# The TRIUMPH Corporation

## SERVICE BULLETIN

65/1

SUBJECT: 1964 Type Fork Springs Fitted to "B" & "C" Range Twin Models as Shown Below.

### REFER TO ATTACHED DRAWING

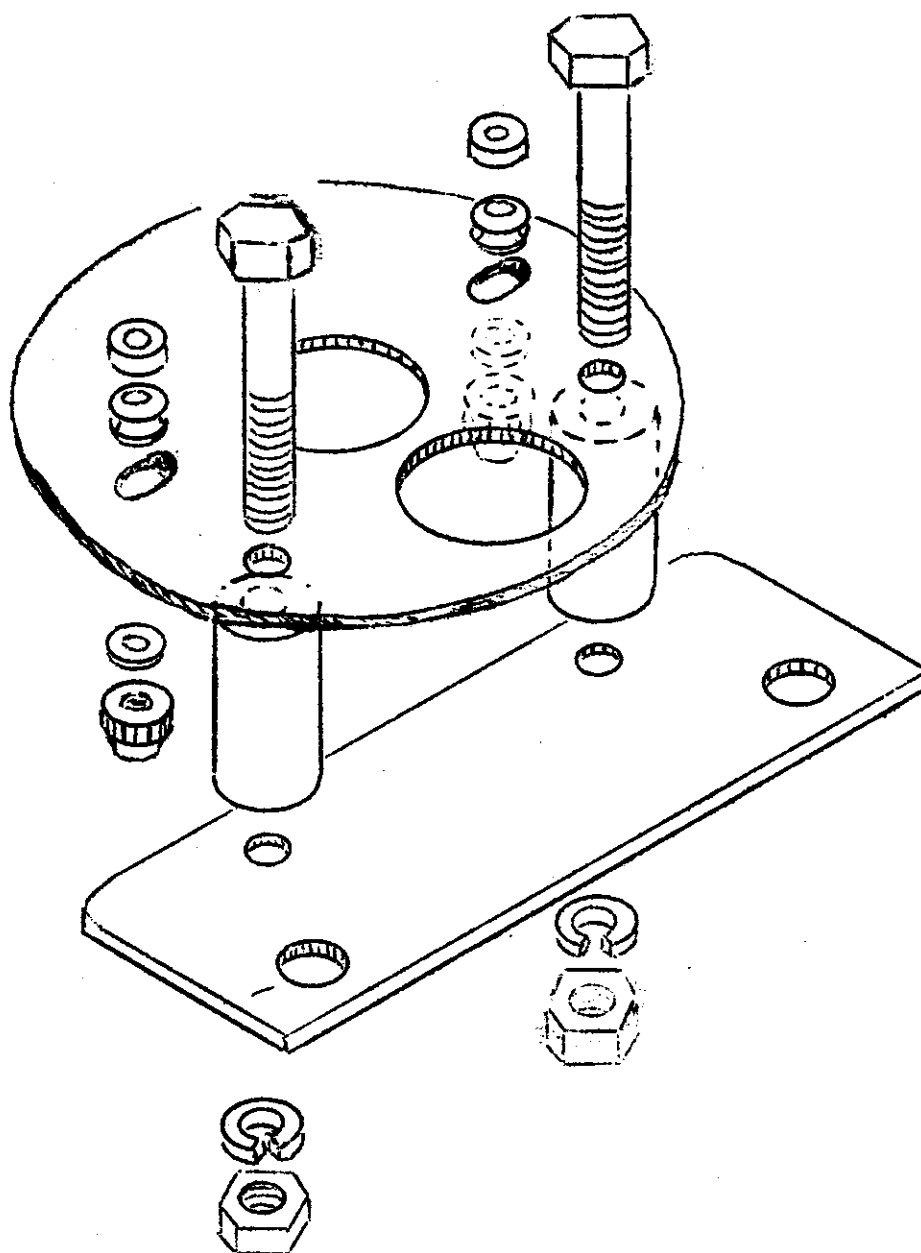
- 1. Fit rubber grommets into two 1/4" obround holes.
- 2. Fit the 1-3/8" mounting bolts in the remaining 1/4" holes and fit the 1" spacers below the mounting plate.
- 3. Affix the assembly to the handlebar lug on 650cc or 500cc models

- 4. If mounting to T20 Tiger Cub, fasten the above assembly to the Steel mounting plate as shown using the 1/4" nuts and lockwashers. This assembly then bolts the "U" bolt handlebar clamps. It will be necessary to move the headlamp as far forward as possible to give proper cable clearance.
- 5. Remove the two thumbnuts and bracket from the VDO Enduro Speedo.
- 6. Connect the instrument light wire and attach speedo cable to VDO Enduro Speedo (Use CD431 VDO Speedo Cable for T20 Tiger Cub and 500cc models and CD432 Speedo Cable for 650cc models.

7. Put the 1/8" spacers on each of the mounting studs and place the instrument on the circular mounting plate pushing the mounting studs through the rubber grommets.
8. Assemble the remaining flat washers onto the mounting studs and replace the thumb nuts using Triumph LOCTITE to avoid loosening.
9. Finally remove the odometer reset knob and set screw and apply Triumph LOCTITE to avoid losing these parts, and reassemble.
